Trig Road Corridor Upgrade Addendum to the 2020 Landscape and Visual Effects Assessment

March 2023

Version 0.3

Figure 1: NoR before design change (Original stormwater dry pond location) between chainage 340-440 at 9 Trig Road. Refer Appendix 3 of existing LVA

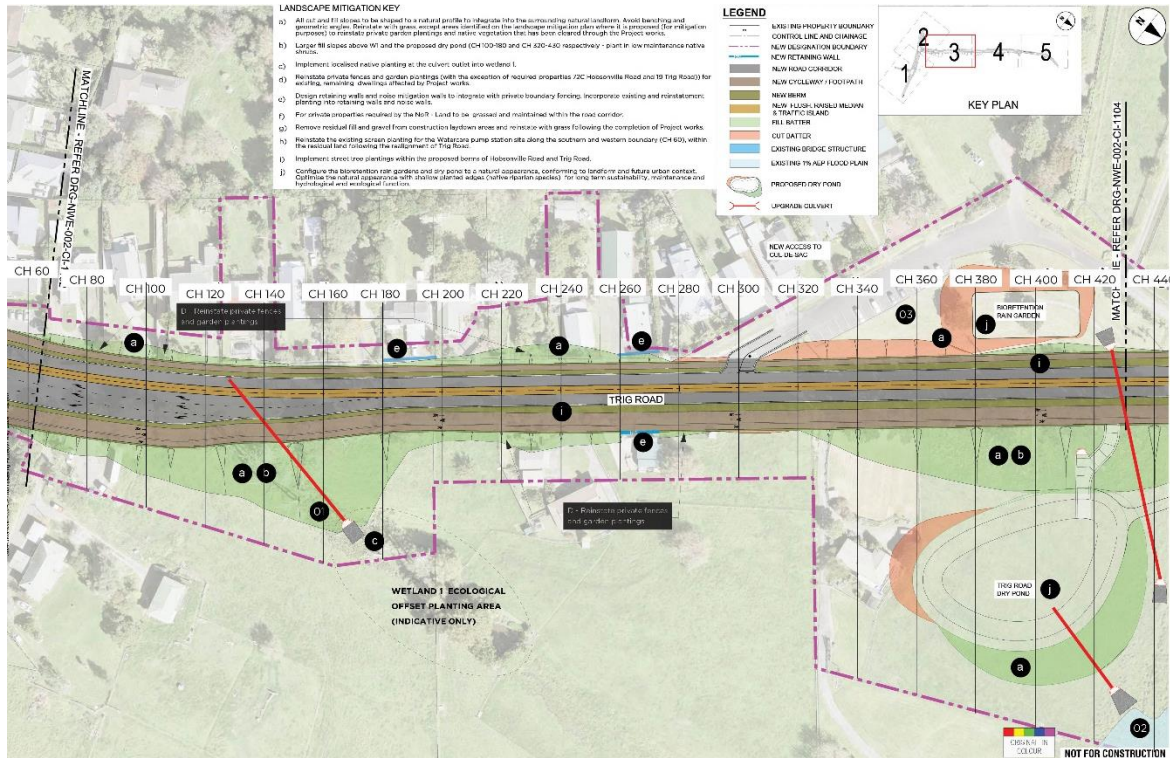
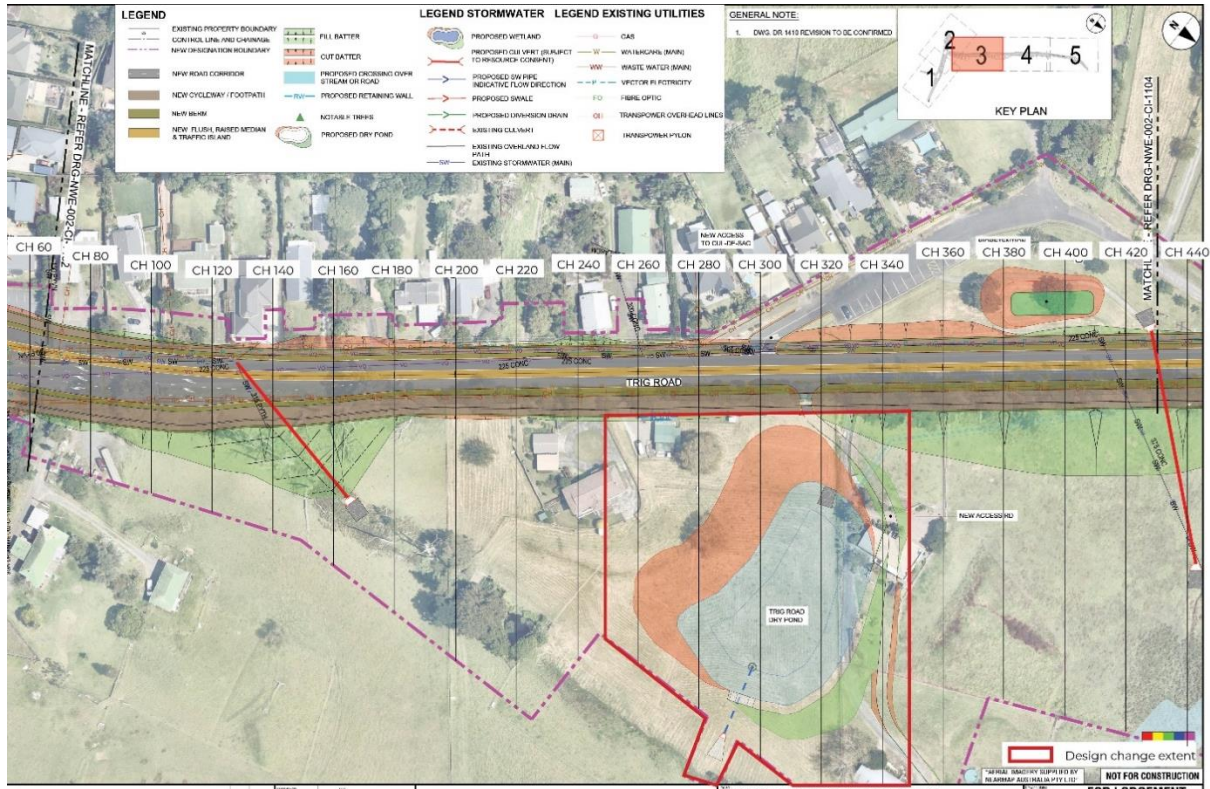
Within the area of NoR, the original design (Map 05, documented in Appendix 2 of the existing LVA), identifies the stormwater dry pond location largely within 9 Trig Road parcel boundary, between CH340-440 (refer Figure 1). The dry pond was originally situated at a low point, within an existing natural wetland and would likely have adverse effects on the wetland’s ecology. In addition, the original proposal involved high volumes of fill batter slopes within proximity to existing wetlands which would considerably alter the landform and natural flow paths associated with it.

The design change in this addendum consists of relocating the stormwater dry pond approximately 90m south from the original location (refer Figure 1) to straddle the boundary between 7 & 9 Trig Road (CH280-350). This change proposal is documented in the Trig Road Resource Consent drawing SGA-DRG-NEW-002-CI-1103 (refer Figure 2). Refer Appendix 1 for reference drawings for the Project.

The objective for the change in location of the attenuation pond was to alleviate adverse ecological effects from potential wetland impact and maintain landscape and natural values. The new location reduces wetland reclamation and is still sufficiently close to the topographical low point to function from a stormwater perspective, whilst maintaining existing stream crossings to the rear of 7 & 9 Trig Road. The proposal reduces the amount of fill batter slopes, thus minimising the level of modification to the natural landform.
